ULNRC-05559

**DOCKET NUMBER 50-483
CALLAWAY PLANT UNIT 1
UNION ELECTRIC CO.
FACILITY OPERATING LICENSE NPF-30
ADDITIONAL INFORMATION PROVIDED TO MISSOURI DNR
CONCERNING GROUND WATER MONITORING**

AURA 2008031

SUBJECT: Callaway Plant Groundwater Monitoring Program

Map of Ground Water Monitoring Wells

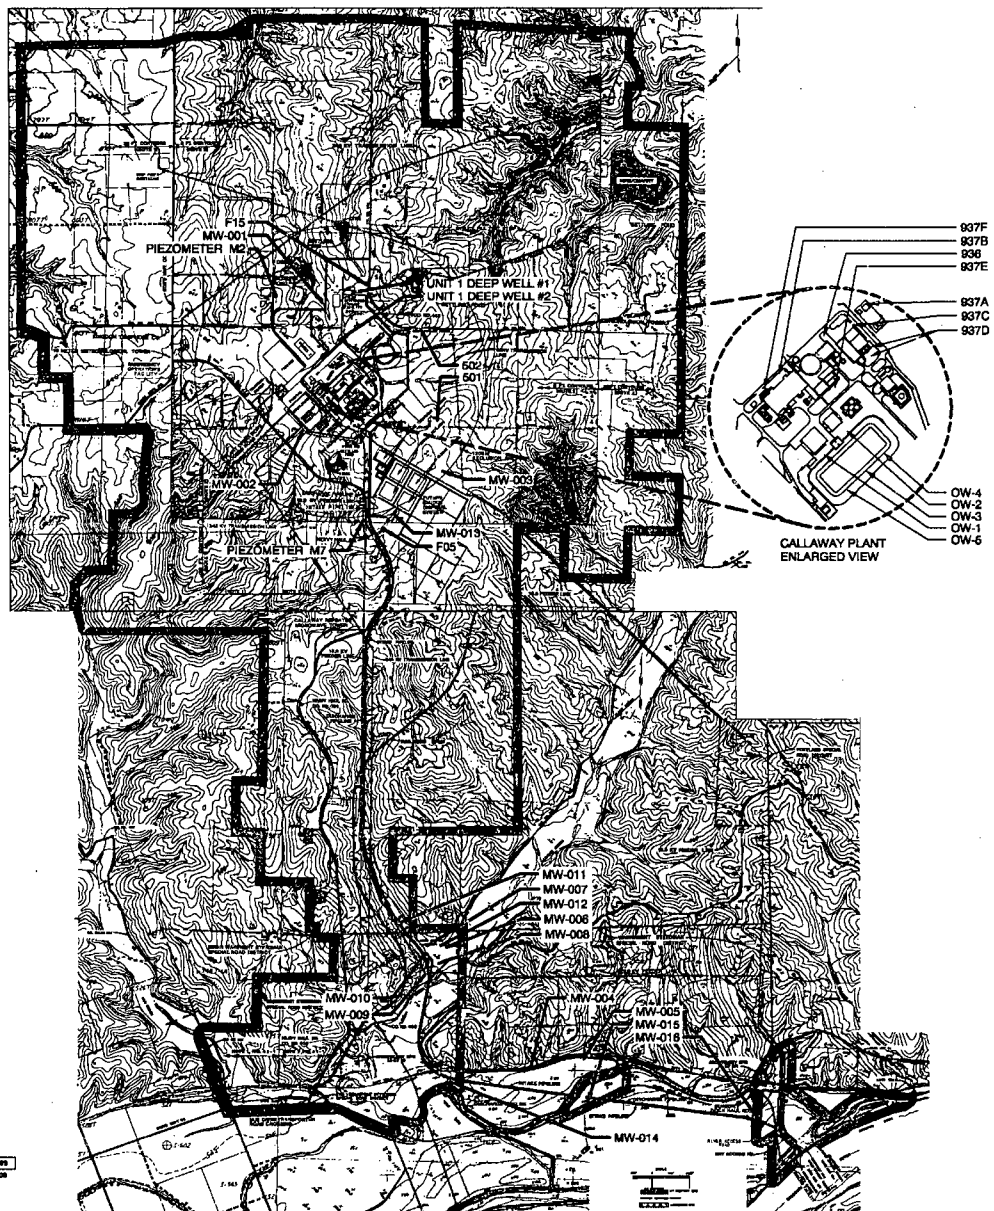
- 7. Table 2.4-25 included by Ameren Services contains water level readings from the ten "permanent" piezometers (M1-M10) located at the facility. An item to note is that the readings are from July and August 1979 and may not accurately reflect the current conditions. As figure 2.4-30 was not included in Ameren Services response, the locations of the piezometers are not known. It is possible that at least some of the ten piezometers are located in undisturbed areas and most likely the information won't be of much value concerning the perched groundwater zone in the filled areas. Because the location of the piezometers is not known, we cannot make a judgment as to whether the**

chosen monitoring points are accurately located to detect releases from the potential sources at the Callaway Plant site.

Attachment D provides a drawing showing the current power block monitoring well locations in relation to buildings and components. The yellow rectangle at the roads surrounding the plant buildings indicates the approximate location of the bathtub area beneath the power block. We believe that the ground water sump and the six power block monitoring wells are positioned appropriately to provide indication of any leakage of radioactive material from a system, structure or component within this power block area. In addition, a more detailed cross-sectional drawing is being generated to provide a better understanding of the power block excavation and location of the monitoring wells.
